30 December 2025Development Assessment
Brisbane City CouncilBy email: dalodgement@brisbane.qld.gov.au**RE: INFORMATION REQUEST RESPONSE: 3 RAMSAY STREET, KEDRON
APPLICATION NUMBER – A006887173**

Please see a response to the items of the information request for application number A006887173, issued by Council on 26 November 2025 below.

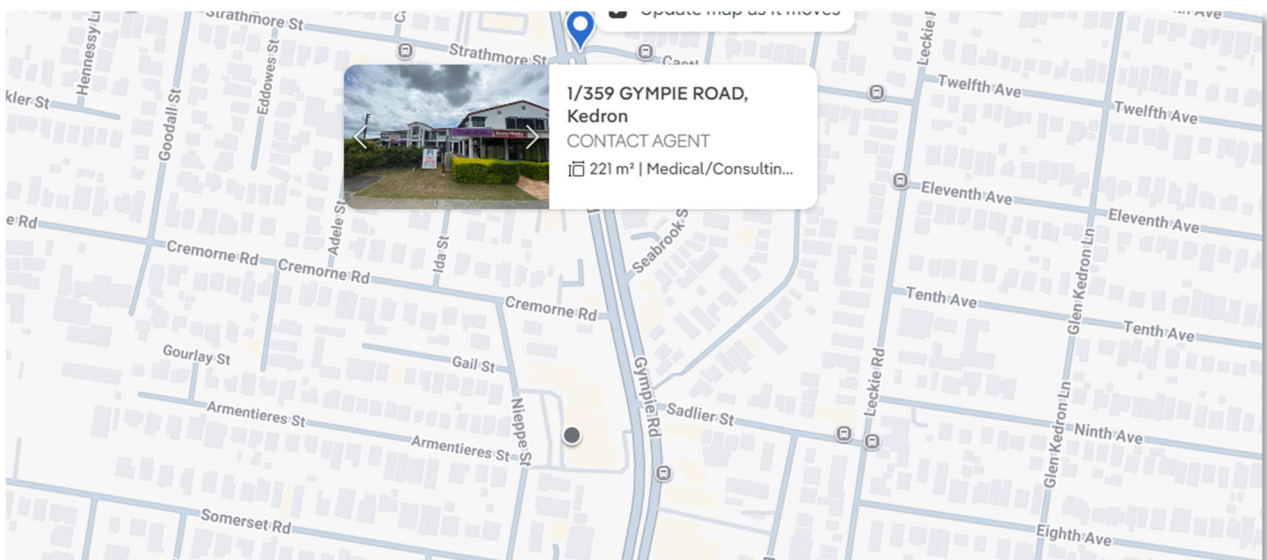
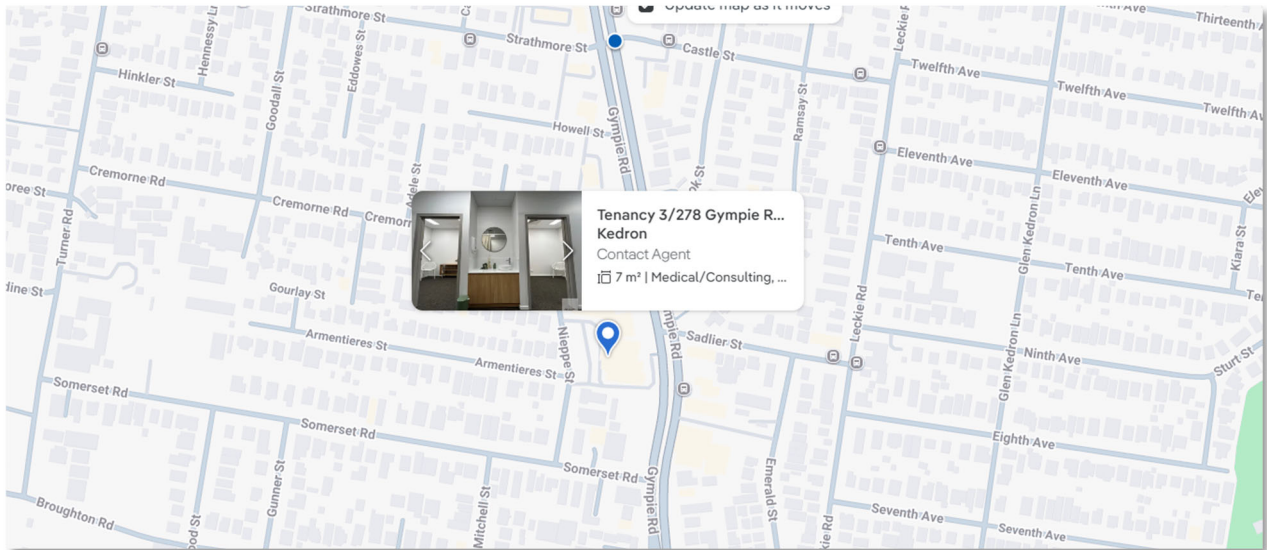
- c. does not contribute to strip development along arterial roads;
- d. must not introduce non-local traffic into a minor road.

The site is slightly setback from Gympie Road, which has historic strip development from Kedron through to Chermside Shopping Centre. Much of that land is located within the Residential Zones, despite having ongoing use rights for non-residential development. In response to item b) above, it has been demonstrated the Sadler Street is a 'rat-run' between Gympie Road and Leckie Road. This access was recently increased with the closure of the 'right-turn' lane into Edinburgh Castle Road to the north.

Ultimately, it is clear that Sadler Street is not a quite residential street and that there is a significant amount of non-local traffic that uses the 'minor road'.

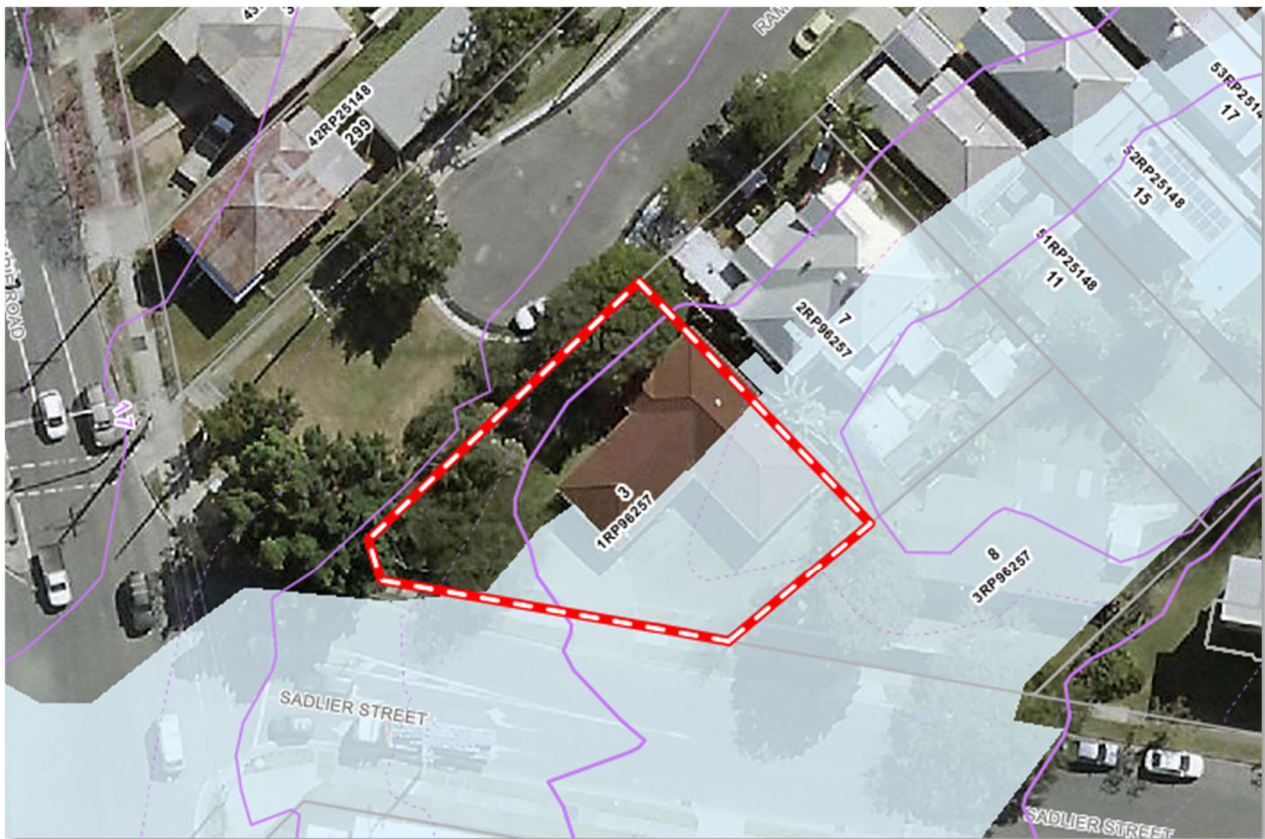
Part of the site (including 75m² of the existing building) is mapped by the Flood overlay Overland flow FPA sub-category. Table 5.10.11 of Brisbane City Plan 2014 indicates that MCU, ROL, building work or operational work other than for a dwelling house, if in the Overland flow flood planning area sub-category will trigger assessment against Section B and Section C of the Flood overlay code.

- a. The Flood overlay will require documentation to be submitted from a suitably qualified Registered Professional Engineer of Queensland to comment on the overland flow characteristics during the

2% AEP defined flood event. It may be necessary to implement measures that are required to mitigate residual risks. Further, photographs and “as constructed” floor and ground surface levels in Australian Height Datum are required to be submitted.
